ExQ2: 03 August 2021

ExQ2	Question to:	Question:
Bio.2 Biodiversity and ecology, terrestrial and marine		
Part 1 – Matters to be dealt with in writing following ISH7 – wet woodland		
Bio.2.0	<p>The Applicant</p> <hr/> <p>SZC Co. Response at Deadline 7</p>	<p>Wet Woodland. Please will the Applicant set out briefly what wet woodland compensation it proposes and its location, especially where combined with Fen Meadow compensation</p> <p>The approach to wet woodland is defined in the Wet Woodland Strategy [REP1-020] provided at Deadline 1. In summary the approach is to provide a total of 3.06ha of compensatory woodland habitats to replace the 3.06ha of wet woodland habitats which will be lost from the Sizewell Marshes SSSI to the footprint of the power station platform and the SSSI Crossing. In addition, the strategy defines wet woodland enhancements which will be delivered in the retained areas of wet woodland on the Sizewell Marshes SSSI, in agreement with Natural England.</p> <p>The strategy proposes delivering 0.7ha of wet woodland in a new wetland corridor south of the main area of wetlands within the marsh harrier habitat improvement area, east of Upper Abbey Farm (see map provi

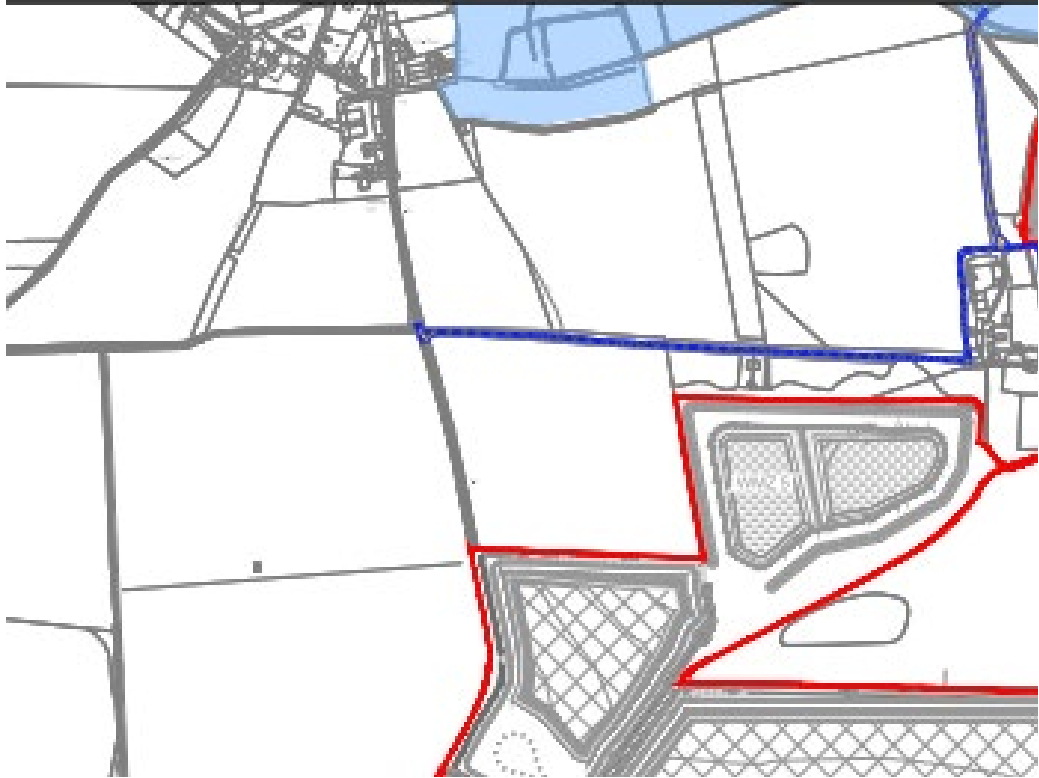
Bio.2.33	Applicant	<p>Bio.1.264 The response puzzles the ExA. (i) The LEMPs for the SLR and TVB were not part of the suite of application documents in May 2020. They do not appear to have been contemplated originally. How therefore can they be "creation and management plans" referred to in the executive summary of the biodiversity report [APP-266] and ExQ1, Bio.1.264? (ii) The ExA repeats the question at Bio.1.264.</p>
	SZC Co. Response at Deadline 7	<p>The BNG assessments for the Sizewell link road and the two village bypass were undertaken using landscape and ecology master plans for these two sites which were available in 2020, [APP-050] and [APP-038] respectively. However, it was recognised that to provide greater certainty that the habitats would be delivered in the manner shown on the masterplans and to provide details to be secured, it was considered prudent to prepare LEMPs for these two sites [AS-263] and [AS-264], in the same manner that had been undertaken for the oLEMP for the main development site. The details in the two LEMPS are entirely aligned with the landscape and ecology master plans and the BNG assessments for these two sites.</p>

ExQ2	Question to:	Question:
		<p>The habitats shown on the landscape and ecology master plans for these two sites which were available in 2020 [APP-050 and APP-038] were designed in accordance with the habitat requirements identified in the ES (e.g. woodland and hedgerow linkages) and did not need the preparation of the later LEMPs for these proposed habitats to be defined spatially. The LEMPs simply provide more details on how this will be achieved and Requirement 22A provides a securing mechanism to ensure the habitat creation will occur in the manner set out in those documents.</p>
Bio.2.34	Applicant	<p>A number of the ExA's questions in ExQs1 on biodiversity and ecology were about monitoring, the criteria for further action depending on the results of the monitoring and what steps should be taken. Considering the answers, is the ExA correct to conclude that the Applicant's overall approach, at least in relation to biodiversity and ecology, is that where monitoring shows that the effects are more significant than shown by the ES, remedial measures to restore matters to no worse than that level of significance are to be taken? Are there any exceptions to that approach?</p>
